Access Compliance Report

Public Rights-of-Way

(Curb Ramps)

Intersection ID: 1002747	Main Street: SAMS_LN	Cross Street: N/A	Location: E
ADA ID: C2CA01F0396E	Ramp Type: Perp	Initial Pass/Fail: Fail	Overall Compliance: No
		Severity Score: 10

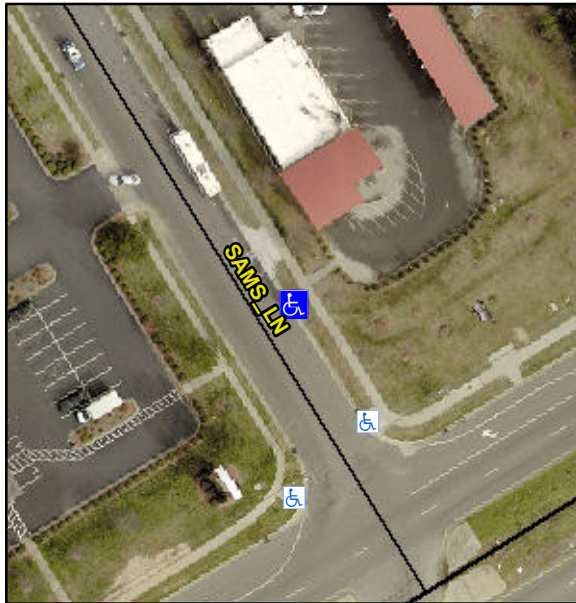
R304.5.1, R304.5.3

Compliance	Description	Data	Compliance	Description	Data
N/A	Ramp Length (in)	96.0	Yes	Ramp Slope (%)	5.3
No	Ramp Width (in)	47.0	No	Ramp XSlope (%)	2.7
N/A	Flare Type LT	N/A	N/A	Flare Type RT	N/A
N/A	Flare Slope LT (%)	N/A	N/A	Flare Slope RT (%)	N/A
N/A	Flare Traversable LT?	No	N/A	Flare Traversable RT?	No
N/A	Landing Length (in)	N/A	N/A	DWS Provided?	N/A
N/A	Landing Width (in)	N/A	N/A	DWS Contrast?	N/A
N/A	Landing Slope (%)	N/A	N/A	DWS Length (in)	N/A
N/A	Landing X Slope (%)	N/A	N/A	DWS Full Width?	N/A
N/A	Landing Curb? (Y/N)	N/A	N/A	DWS Offset (in)	N/A
N/A	Shared Landing?	N/A			
N/A	Gutter Ponding?	N/A	N/A	Gutter Slope (%)	N/A
N/A	Gutter Lip Ht (in)	N/A	N/A	Gutter X Slope (%)	N/A
N/A	Painted X Walk1?	No	N/A	Painted X Walk2?	N/A
	X Walk 1 Direction	To W		X Walk 2 Direction	N/A
N/A	X Walk 1 Width (in)	N/A	N/A	X Walk 2 Width (in)	N/A
	X Walk 1 Slope (%)	0.3		X Walk 2 Slope (%)	N/A
	X Walk 1 X Slope (%)	1.8		X Walk 2 X Slope (%)	N/A

Remove & Replace Entire Ramp.
